URBAN DESIGN CONSULTATION RESPONSE

Design Officer	Azhar Kapadi
Date	29.09.26
Application Reference	PL2026/0728
Address	Land adjacent to 23 Grove Road, Middleton, Manchester, M24 2LZ
Proposal	Erection of three storey building comprising 6 x 1 bedroom flats with associated car parking and boundary treatment

Scheme Image(s)

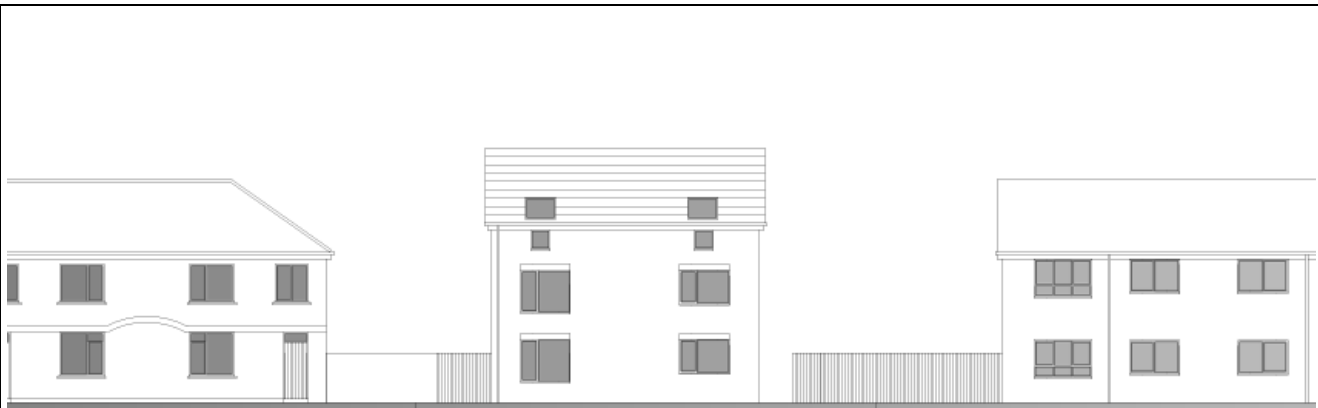
The proposal appears overly large for the plot, resulting in a building that is unduly dominant within the street scene. The three-storey form is uncomfortable in its context and exacerbates concerns regarding scale and massing.

Frontage parking dominates the proposal and detracts from the quality of the street scene. Whilst some parking within the front curtilage may be acceptable, there has been little attempt to retain or reinforce the landscaped character of the area. The result is a harder, more visually intrusive form of development that sits uncomfortably within its surroundings and creates a disruptive infill plot.

The fenestration is one of the weakest aspects of the scheme. Window openings appear randomly positioned, with little regard for alignment, proportion or composition. The elevations lack any discernible order and fail to relate to one another in a coherent manner. The relationship between the upper-floor windows and the roof form is particularly awkward, giving the impression of an unresolved design.

There is also little confidence that the proposed materials will significantly improve the scheme. Beyond a reference to red facing brickwork, no meaningful design rationale or detailing has been provided. The application lacks any real site analysis; the proposal lacks the architectural features commonly found within the local context, such as brick detailing, banding, articulated openings, bays, chimneys or variations in brickwork treatment.

It appears the designer possibly has taken inspiration from the building south of the site (No.135/137) and even then, they have not managed to capture the composition and discipline of the windows.

The elevations lack any coherent design approach. They are inconsistent and bear little relationship to one another, never mind the wider street scene. The three-storey form is not working and only serves to emphasise the awkward proportions of the building. There is also a notable lack of visual interest, with no meaningful articulation, depth or architectural features to break up the massing, resulting in a flat and uninspiring appearance.

There is a clear lack of design rigour throughout the submission, reflected in both the quality of the proposal and the limited detail provided. Even the submitted elevations contain basic labelling errors, which does little to inspire confidence.
